# APOLLO 13 MISSION REVIEW

HEARING  
BEFORE THE  
COMMITTEE ON  
AERONAUTICAL AND SPACE SCIENCES  
UNITED STATES SENATE  
NINETY-FIRST CONGRESS  
SECOND SESSION

JUNE 30, 1970

FIGURE 1. Oxygen tank No. 2 internal components.

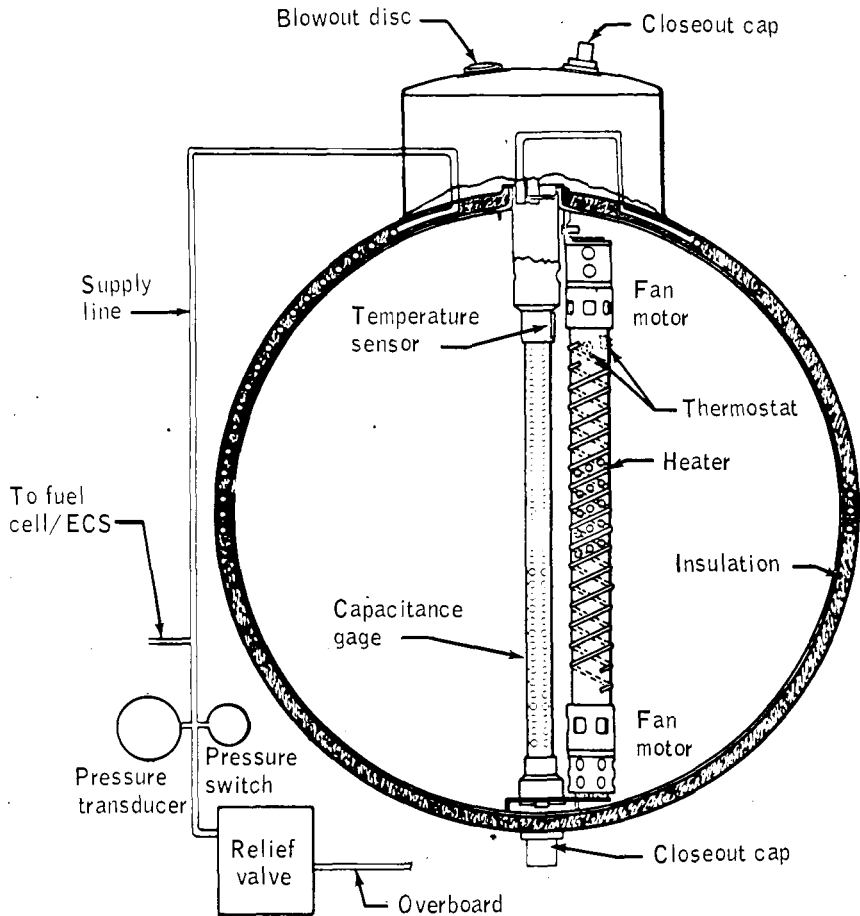
Slide 1 (see fig. 1) shows the simplified drawing of the oxygen storage tank in which the accident occurred. I will just say a brief word about this slide to orient you to the nature of the problem that was encountered.

FIGURE 2. Oxygen tank wiring and lines.

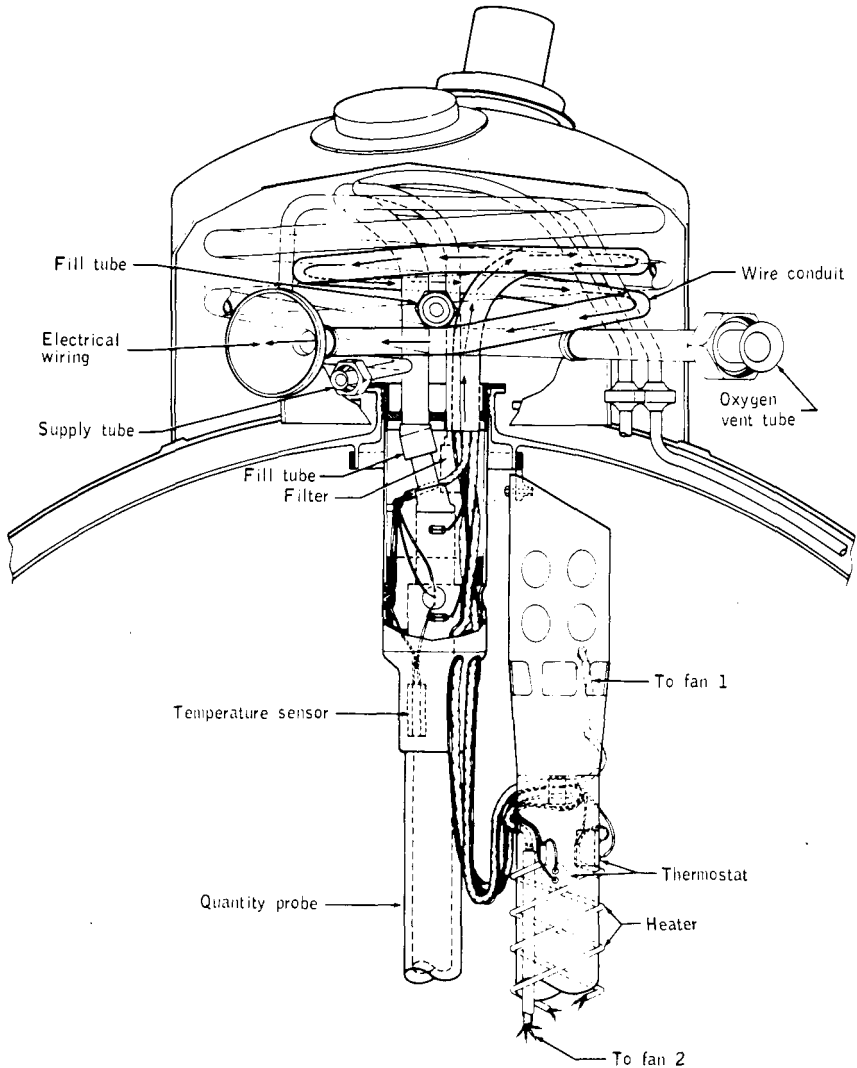
Now, the second slide (see figure 2) shows this in a little more detail. As you can see at the top of the heater-fan assembly the word "thermostat" is shown with two arrows. These arrows point to the two thermostatic switches which failed. In addition, there is a fill tube assembly shown right here at the top of the quantity probe which was loose in a manner which I will describe in just a moment and this led to a special detanking procedure which failed those switches and ultimately damaged the wiring.

Now, in addition to these thermostatic switches which subsequently failed, it is probable that the tank contained a loosely fitting fill tube assembly which I just pointed out. This assembly was probably displaced during subsequent handling after shipment and this handling included an incident at the prime contractor's plant in which the tank was jarred.

FIGURE 3

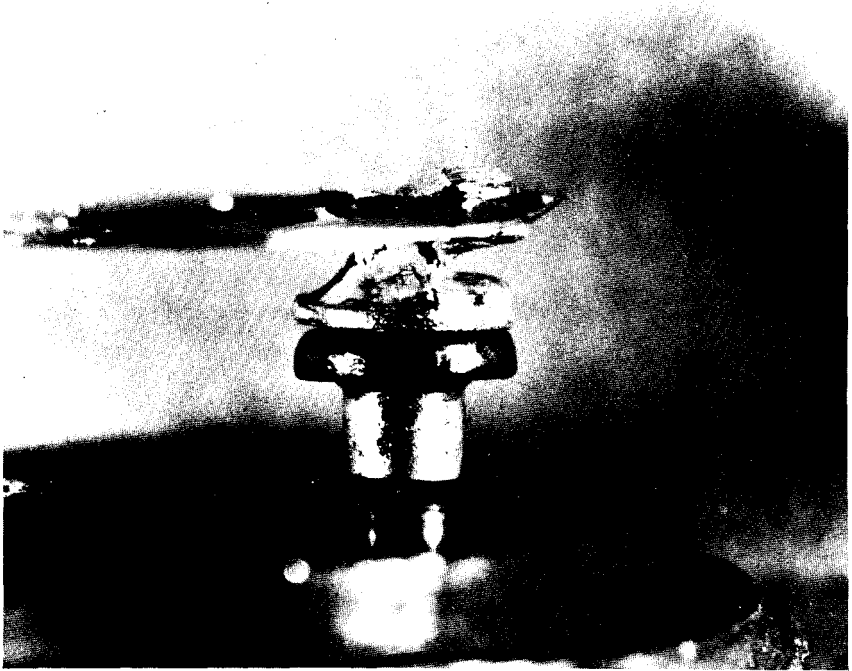
Now, the next slide (see fig. 3) shows a photograph of a switch

which was failed with this current during tests at the Manned Spacecraft Center. The drawing is in the report and in the statement that I submitted today—the photograph is in there.

FIGURE 13

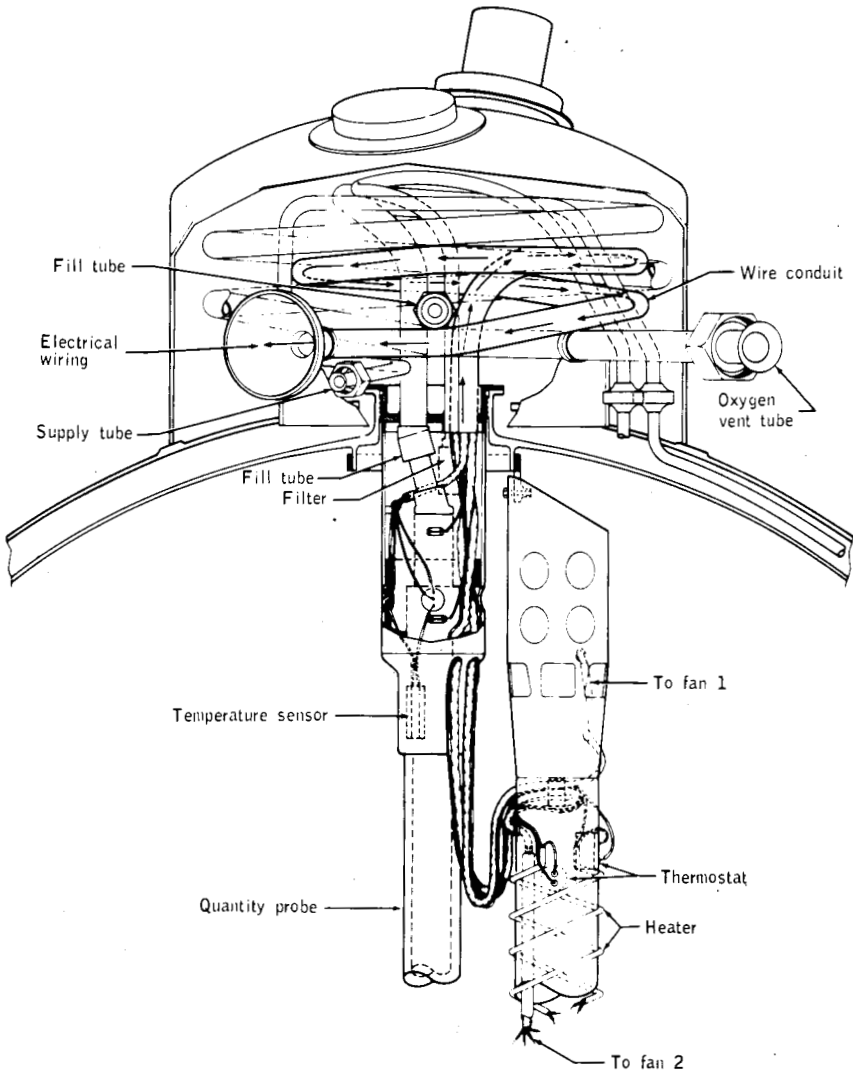
As shown in figure 13, each heater coil is protected with a thermostatic switch, mounted on the heater tube, which is intended to open the heater circuit when it senses a temperature of 80°F. As I will point out later in tracing the Board's conclusions as to the cause of the accident, when the heaters were powered from a 65 volt DC supply at KSC during an improvised detanking procedure, these thermostatic switches, because they were rated at only 30 V DC, could not prevent an overheating condition of the heaters and the associated wiring. Tests conducted for the Board indicate that the heater tube assembly was probably heated to a temperature of as much as 1000°F during this detanking procedure.

FIGURE 18

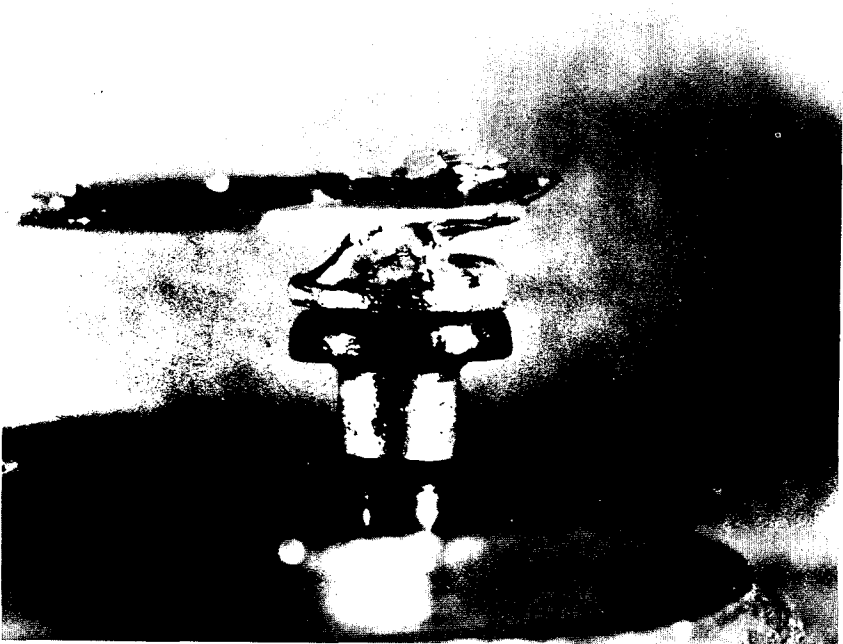
As I noted earlier, each heater is protected with a thermostatic switch, mounted on the heater tube, which is intended to open the heater circuit when it senses a temperature of about 80°F. In tests conducted since the accident, however, it was found that the switches failed to open when the heaters were powered from a 65 volt DC supply similar to the power used at KSC during the detanking sequence. Subsequent investigations have shown that the thermostatic switches used, while rated as satisfactory for the 28 volt DC spacecraft power supply, could not open properly at 65 volts DC with 6-7 amps of current. A review of the voltage recordings made during the detanking at KSC indicates that, in fact, the switches did not open when the temperature of the switches rose past 80° F. Figure 18 shows a thermostatic switch welded closed after application of 1½ amperes of 65 volts DC. Further tests have shown that the temperatures on the heater tube subsequent to the switch failures may have reached as much as 1000°F during the detanking. This temperature can cause serious damage to adjacent Teflon insulation, and such damage almost certainly occurred. Figures 19 and 20 show the condition of wires, such as those used in the fan motor circuit, after they have been subjected to temperatures of about 1000° F.

FIGURE 23

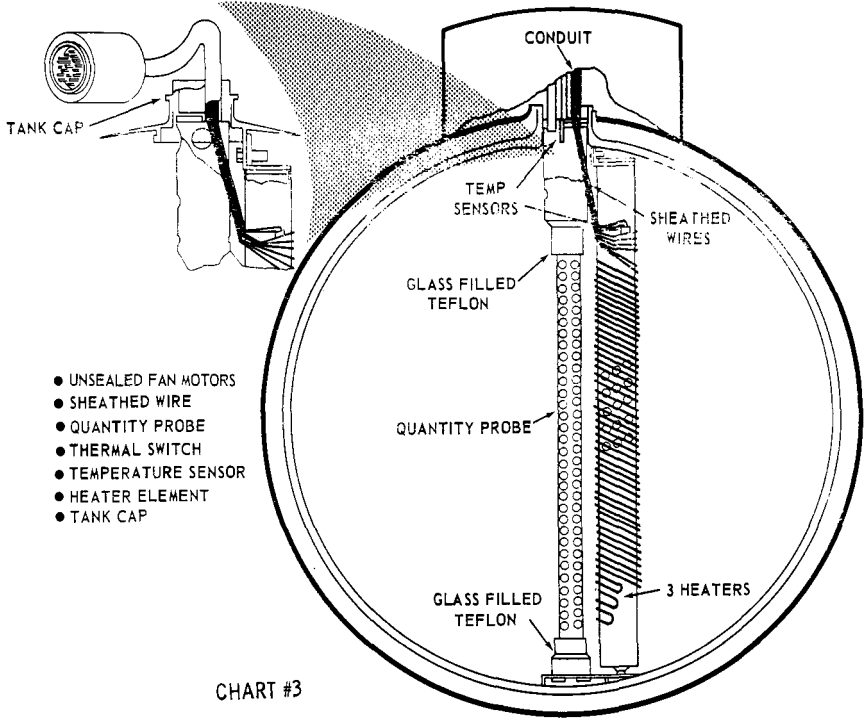
On chart 3 (fig. 23), I show a basic drawing of what the tank would look like schematically with our modifications. The items on the left are notes which would say, one, we are going to remove the unsealed fan motors. We will use sheathed wires. The quantity probe, which we have to retain will be changed from aluminum to stainless steel. The thermal switches will have been removed. The temperature sensor, the second one will have been added. As I mentioned, we will add a third heater element for redundancy. The tank cap will be modified to simplify the basic installation of the heater probe assembly.
